1982 Service Manual Up-Date

All Models Except
Firenza

1982 SERVICE MANUAL UPDATE

This manual provides corrected or additional information that was not included in the 1982 Chassis Service Manual and the 1982 Omega and Cutlass Ciera Service Manual. In cases where information can-not easily be added to a service manual, it is suggested that a notation be made in that particular service manual to refer to this manual.

Fig. 1C1-1—Removing Poly Groove Clutch Coil
- Replaces Fig. 1C1-22

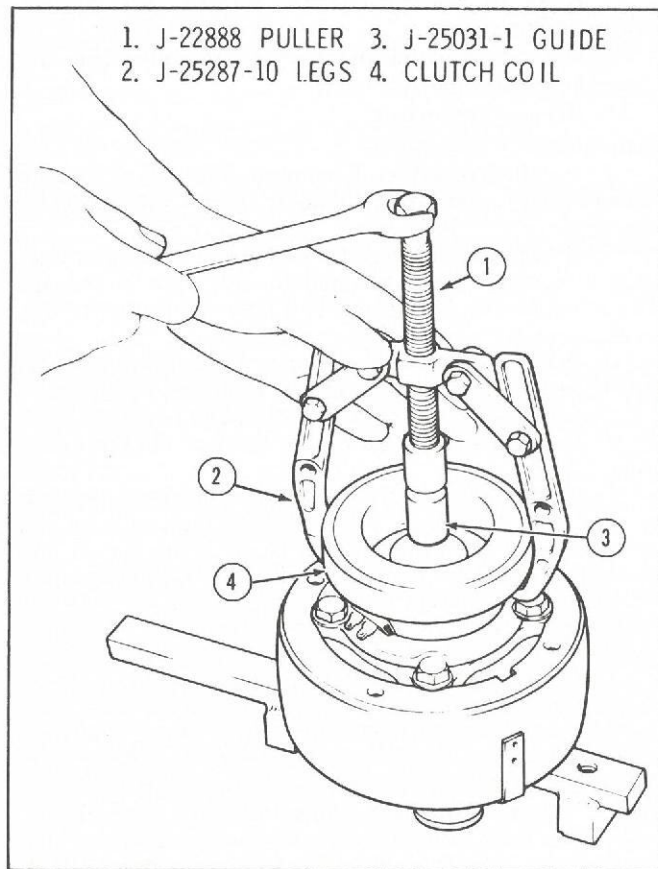
The following is the revised procedure for removal of the poly groove clutch coil from the A/C compressor for the 1982 Cutlass Ciera equipped with a 4.3L (V-6) Diesel.

3. Install guide J-25031-1 to the front head, then install puller J-22888 using puller legs J-25287-10 and remove the clutch coil from the front head. (Fig. 1C1-1).

Fig. 3-2—Power Rack and Pinion Steering Assembly - Replaces Page 3B2-9

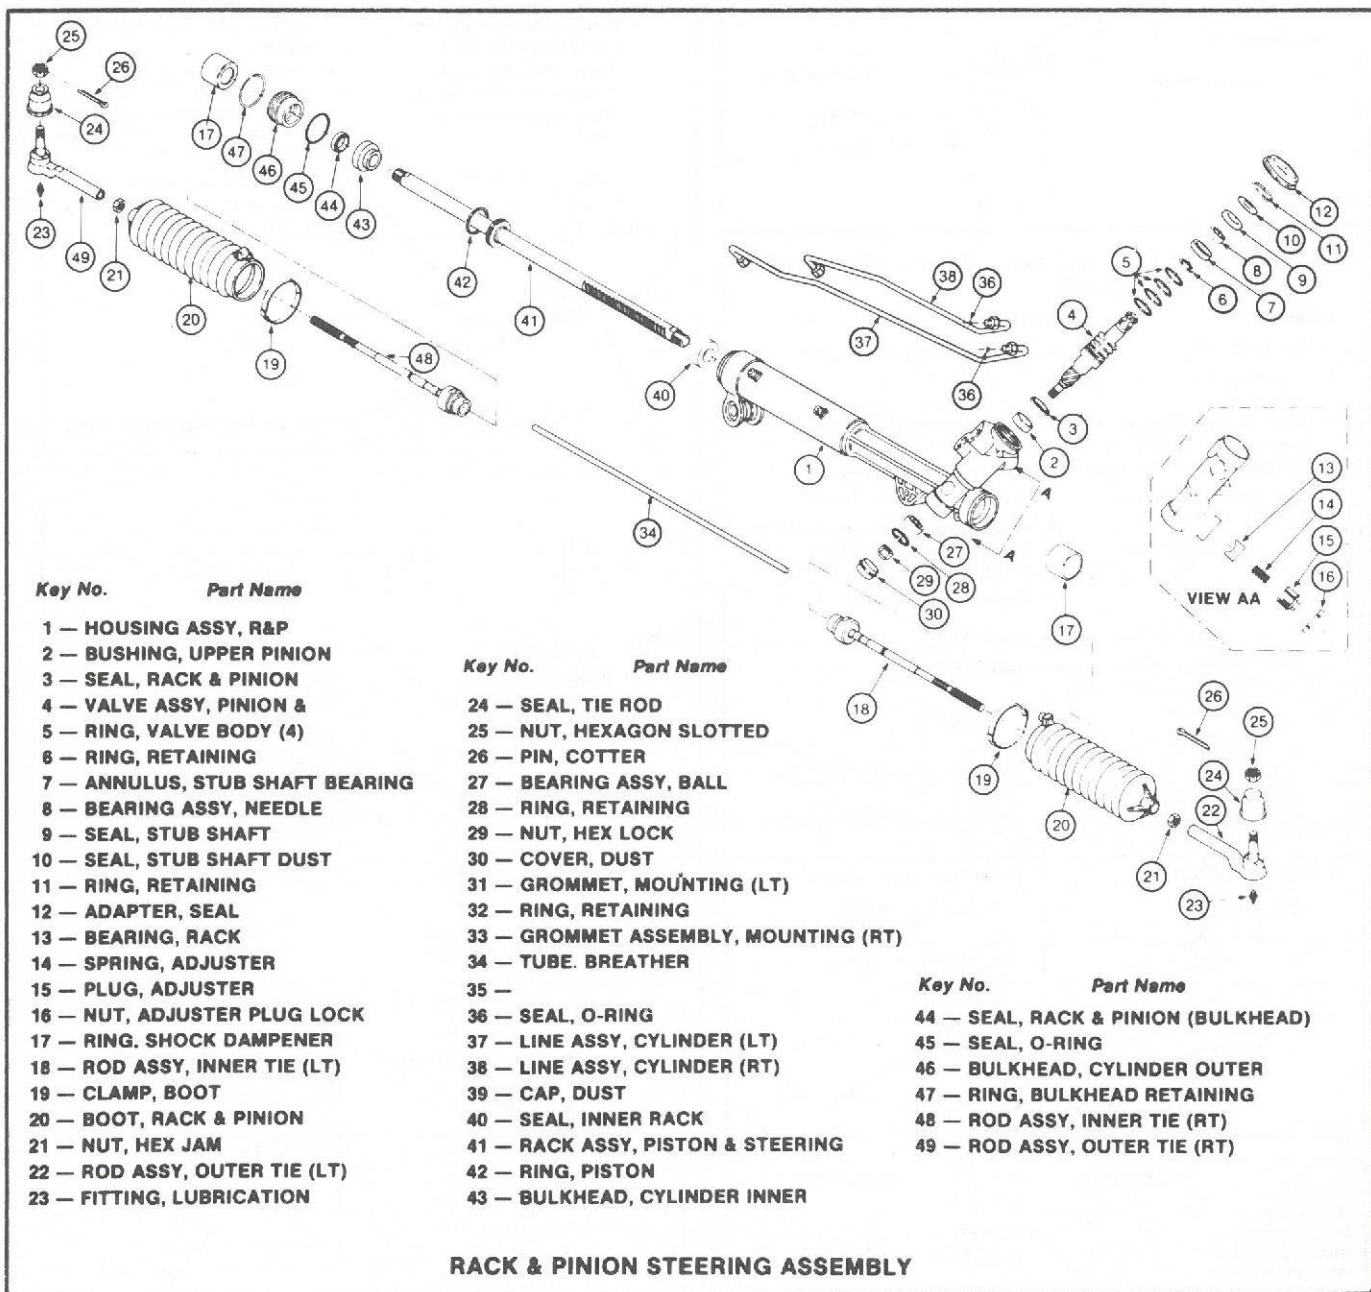
1. REMOVE AND INSTALL OUTER TIE ROD

1. Loosen jam nut.
2. Remove tie rod from steering knuckle, using Tool J-24319-01 or BT 7101.
3. Remove outer tie rod.

Fig. 3-9—Power Steering Hose Routing (Gasoline Engines) - Replaces Figure 3B3-7

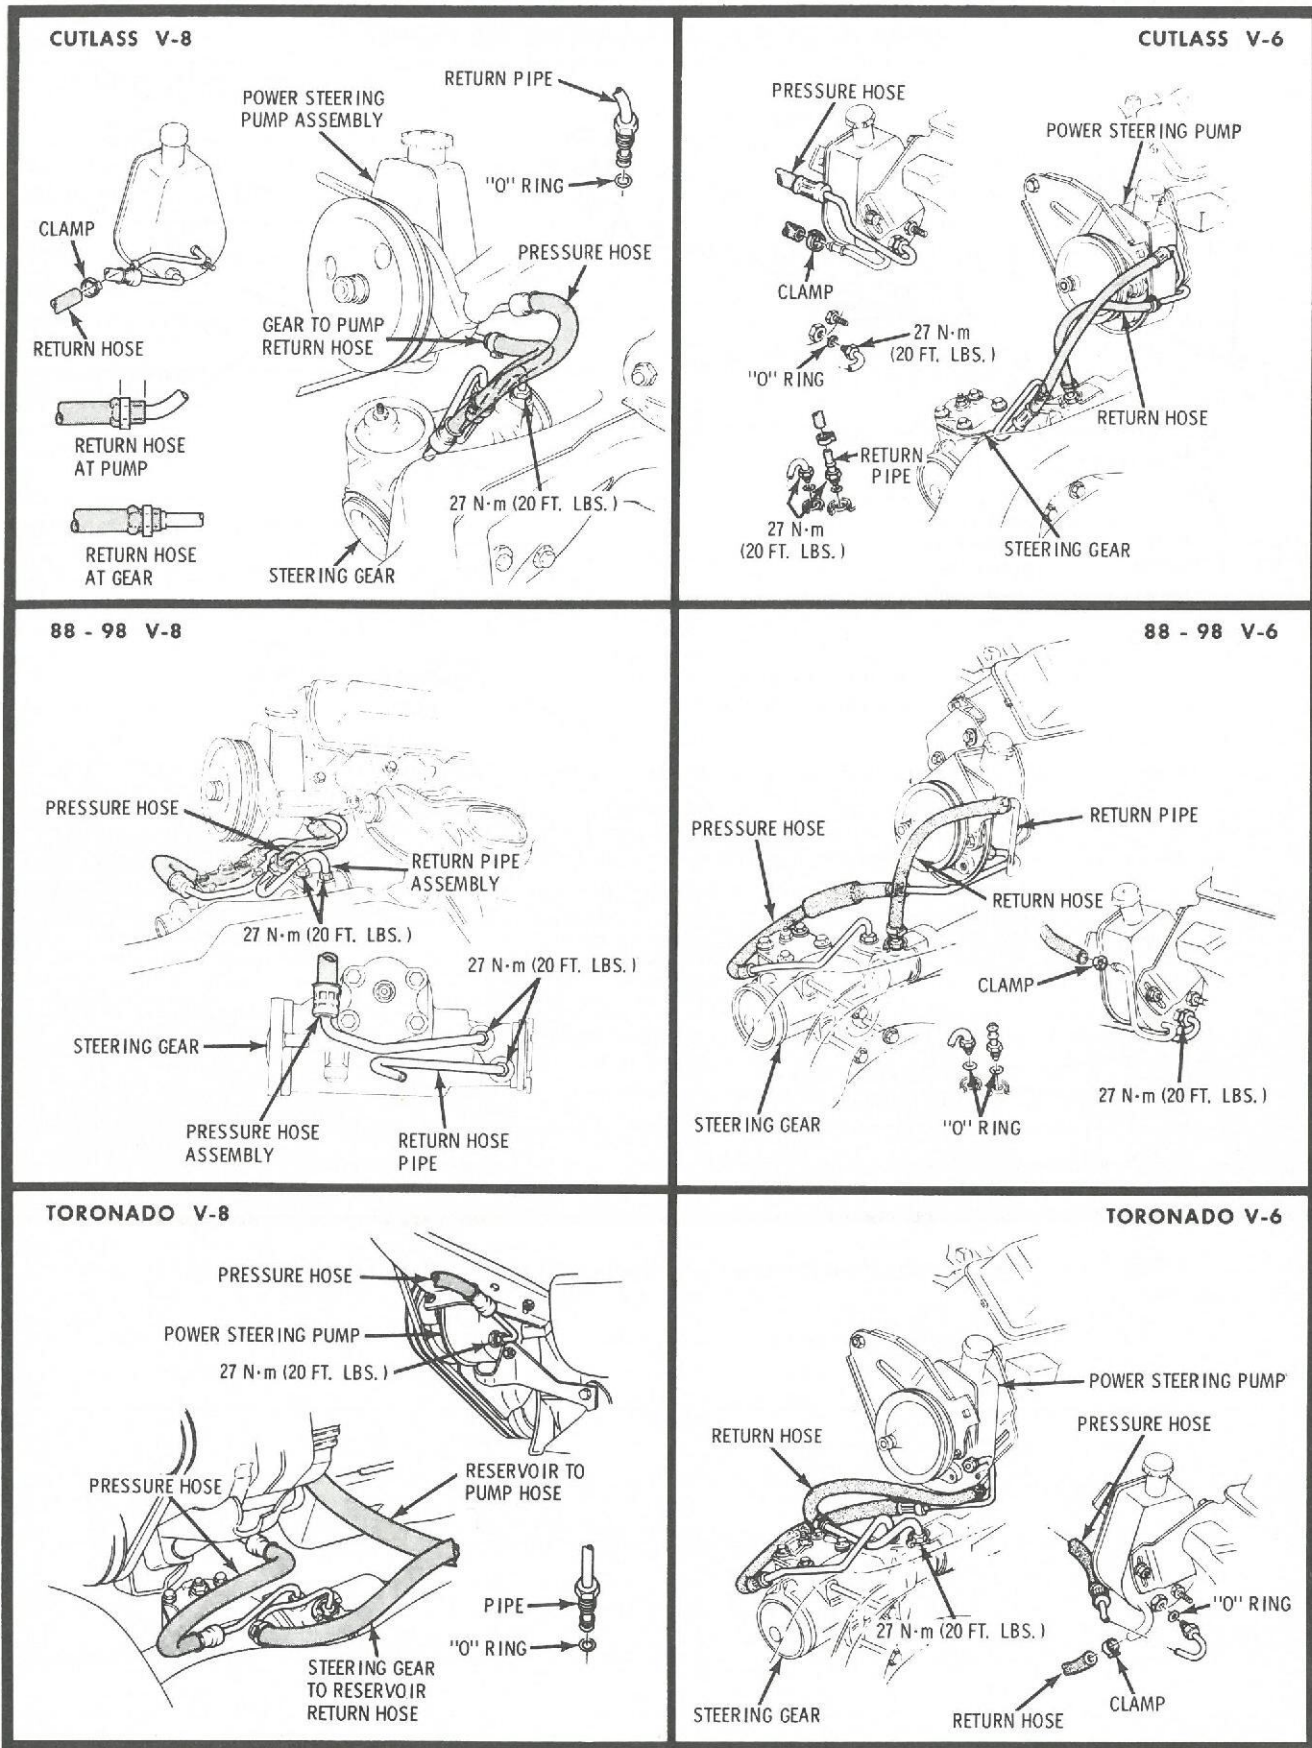
POWER STEERING HOSE ROUTING - GASOLINE ENGINES

Fig. 3-14—Steering Column Lower Bearing Retainer - Omega & Cutlass Ciera

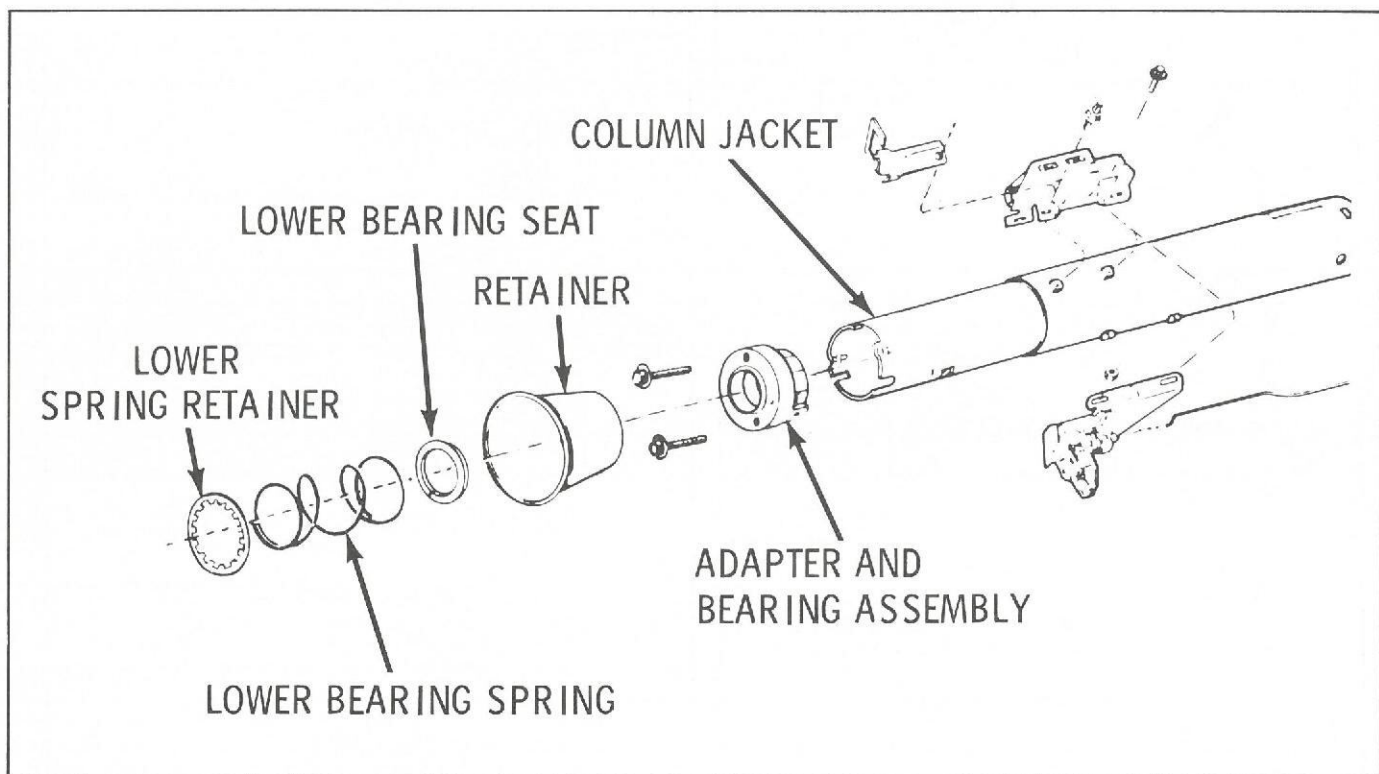
The lower bearing retainer used on Omega and Cutlass Ciera steering column is attached to the column using a retainer which slips onto the steering shaft. (Fig. 3-14)

Fig. 3-18—Omega Rear Spring Positioning

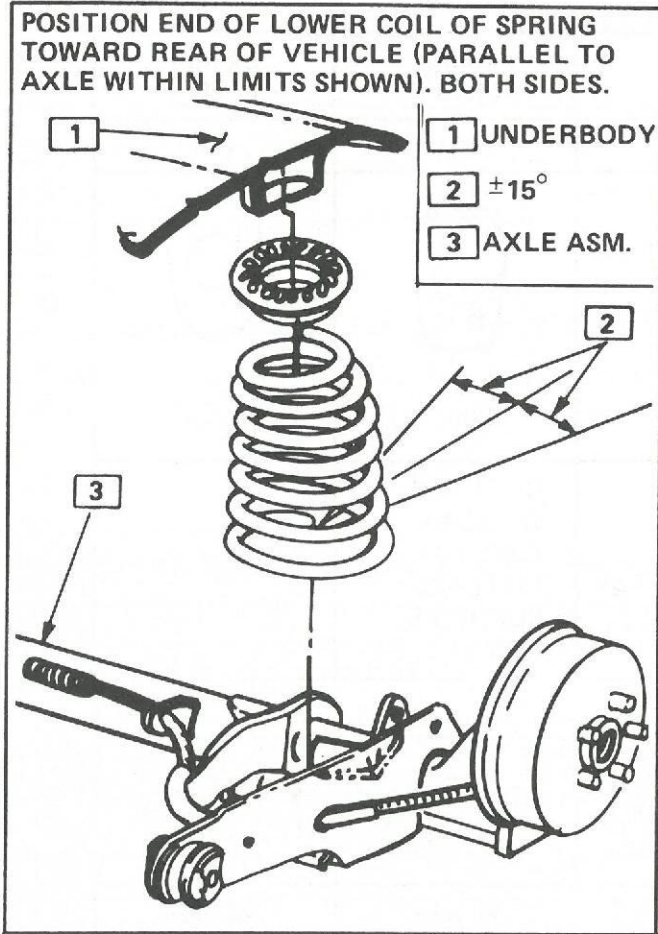
Fig. 3-18 illustrates the correct rear spring positioning on the Omega only. Both rear springs must be positioned with the end of the lower coil toward the rear of the vehicle (parallel to axle center line) within $\pm 15^\circ$. Note this on page 3D-3 of the Omega and Cutlass Ciera Service Manual.

Fig. 5-6—Hydro-Boost Assembly - Replaces Figure 5-44

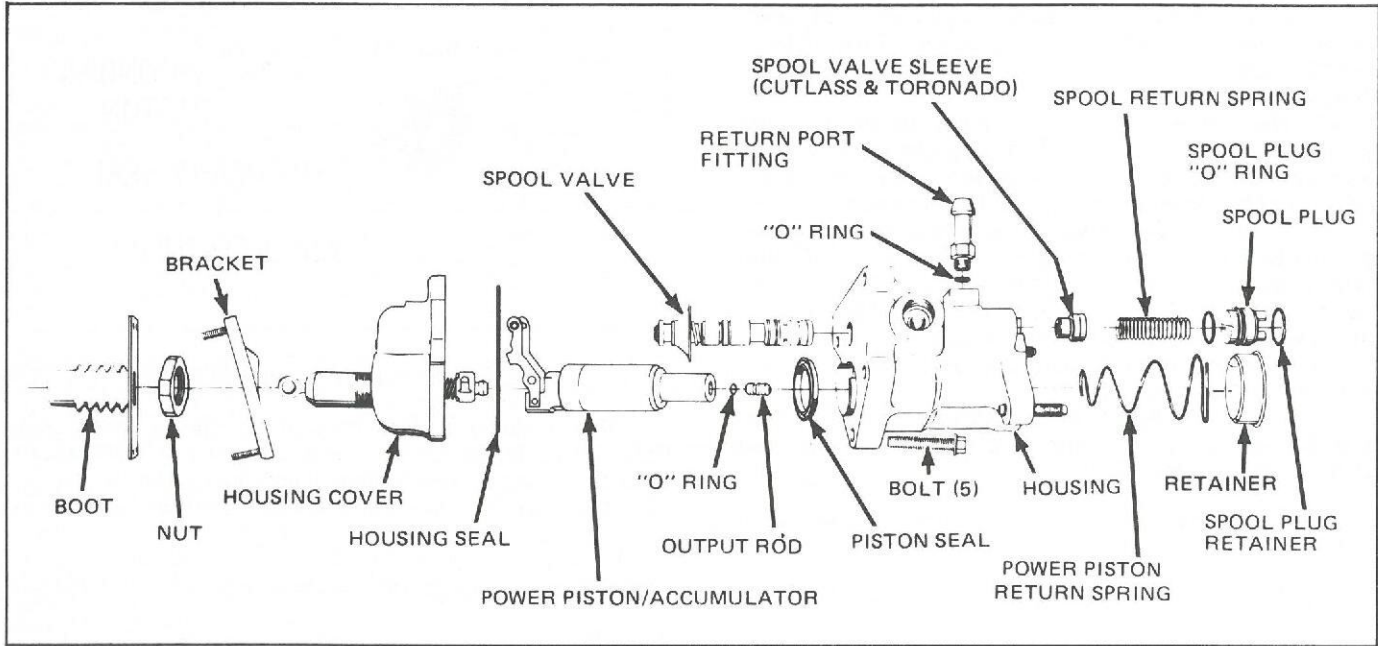
The spool valve sleeve shown in Figure 5-6 is used on Cutlass and Toronado models only. The purpose of the spool valve sleeve is to limit the pressure to the brake calipers to approximately 2300 psi.

Fig. 6B-1 Engine Fan Clutch Installation – VIN V

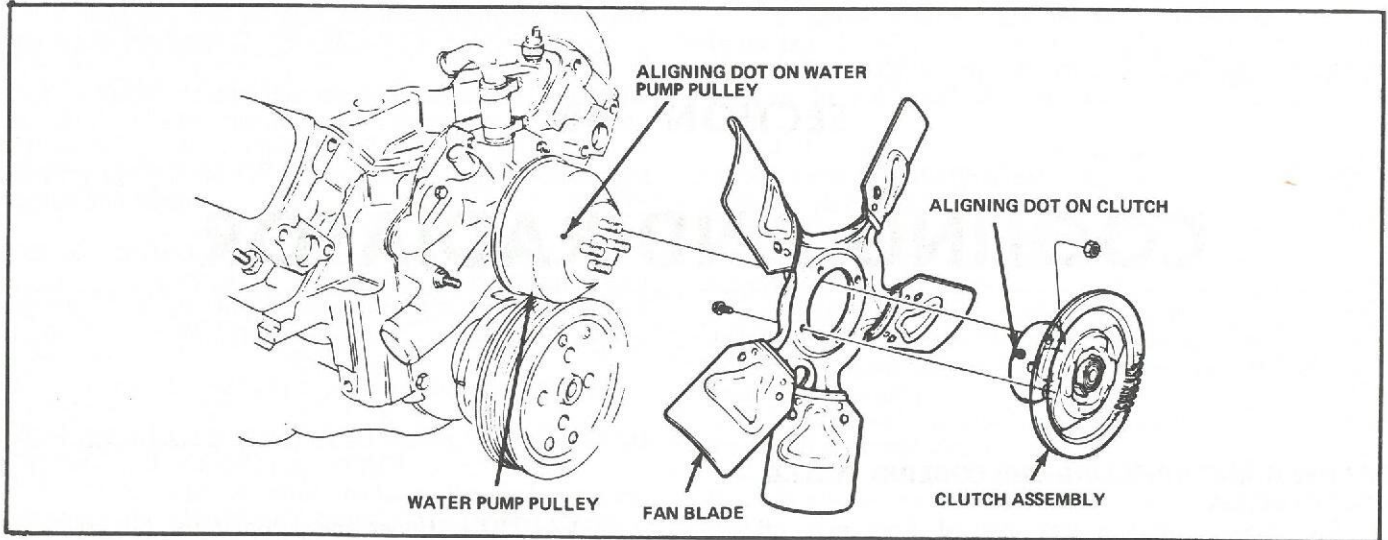
The fan blade clutch assembly has a yellow dot on the clutch assembly mounting flange which MUST be aligned with the yellow dot on the water pump pulley. See Fig. 6B-1.

Fig. 6E2-24—Idle Air Control Valve Identification

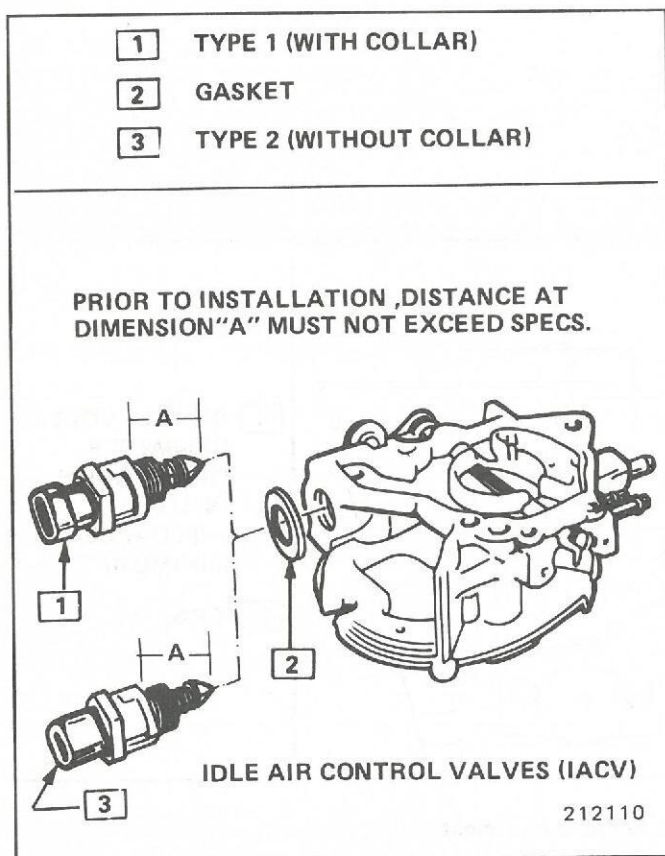
NOTICE: Before installing new idle air control assembly, measure the distance that the conical valve is extended. Measure the distance from the gasket mounting surface on the motor housing to the end of cone (see Figure 6E2-24). Distance should not exceed 28mm (1-1/8"). If the cone is extended too far, damage may occur to the motor when installed.

Identify replacement IACV assembly as being either Type I (having collar at electric terminal end) or Type II (without collar). If measured dimension "A" is greater than 28mm (1-1/8"), distance must be reduced as follows:

Fig. 8A-5—Baro Sensor Location

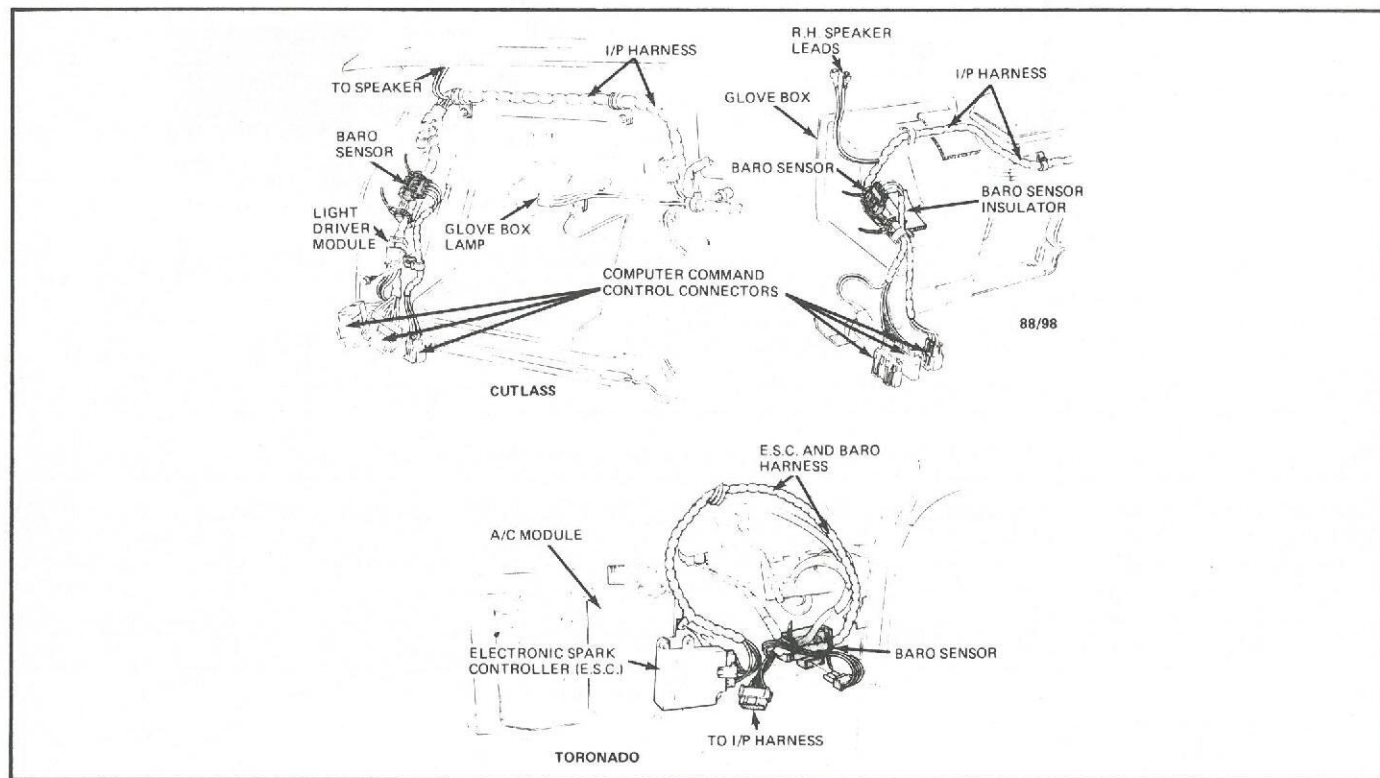
The location of the Barometric Pressure (BARO) Sensor as described in component location charts in the Electrical Troubleshooting Manual (ETM) is incorrect. Figure 8A-5 shows the correct location of the BARO sensor on Cutlass, 88/98 and Toronado. Note these corrections in the component location chart on the following pages of the ETM:

Fig. 8A-7—A/C Temperature Cut-Out Relay

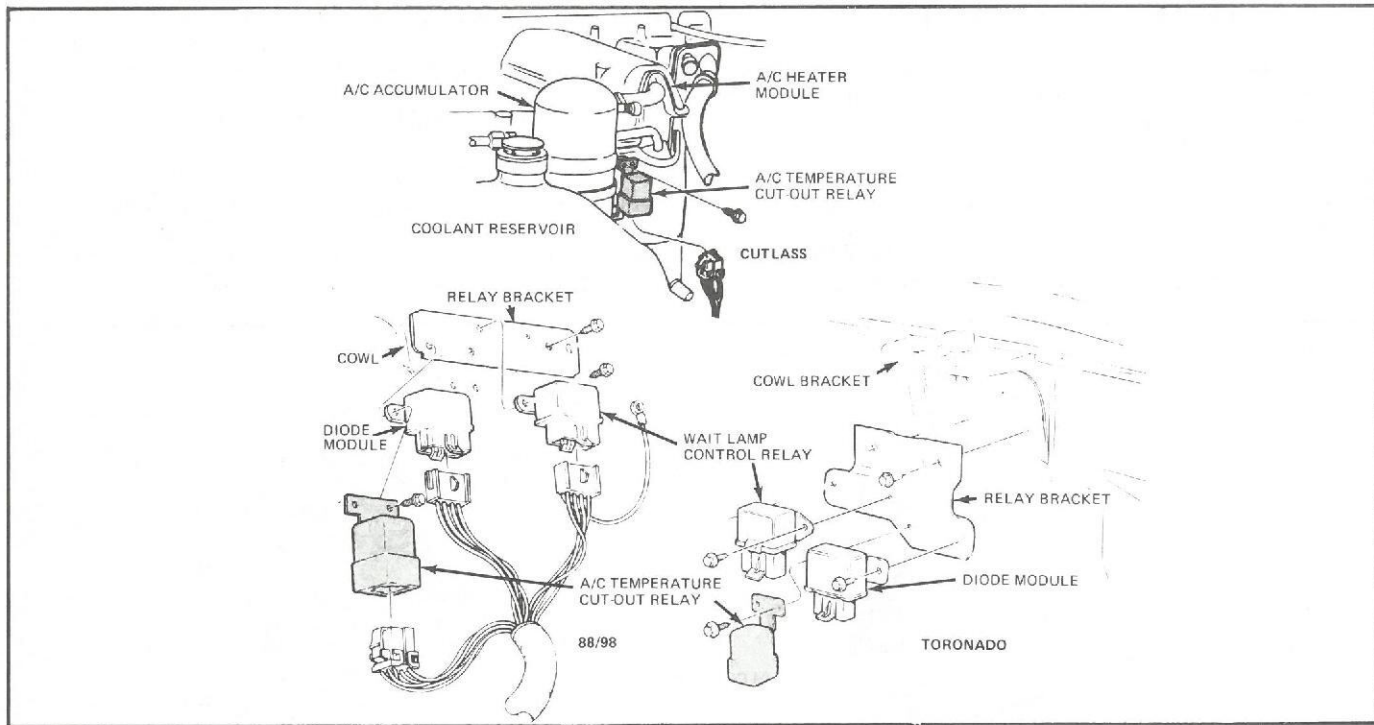
Figure 8A-7 shows the exact location of the relay for each model. Reference this figure whenever troubleshooting A/C compressor clutch conditions.
